No. 89-32

## Water Ingestion on MerCruiser V6/V8 Stern Drive and Inboard Engines

Exhaust Elbow Trough Kit 813070A1

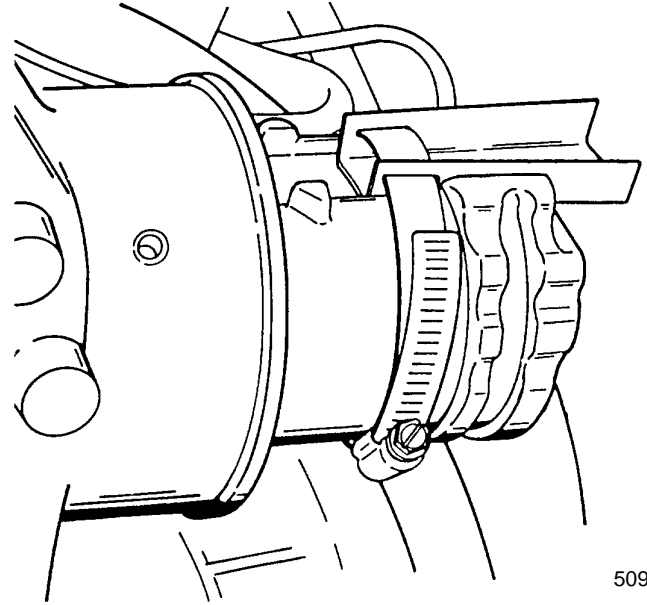
Under certain operating conditions, V6/V8 engines equipped with thru transom exhaust systems may ingest (suck) water back into the exhaust manifold. This condition is caused by the design of the exhaust system from the exhaust manifold elbow (on the engine) back.

If you have an engine with this condition, install Exhaust Elbow Trough Kit. This kit cannot be installed on engines that have Quicksilver Mufflers (P/N 42-17705A3), Below Swim Platform Kit (P/N 18563A1) or Silent Choice Exhaust System.

**IMPORTANT: Before installing this kit, make sure the engine is mechanically sound. Check for stuck valves, fouled spark plugs, or other internal damage caused by water ingestion.**
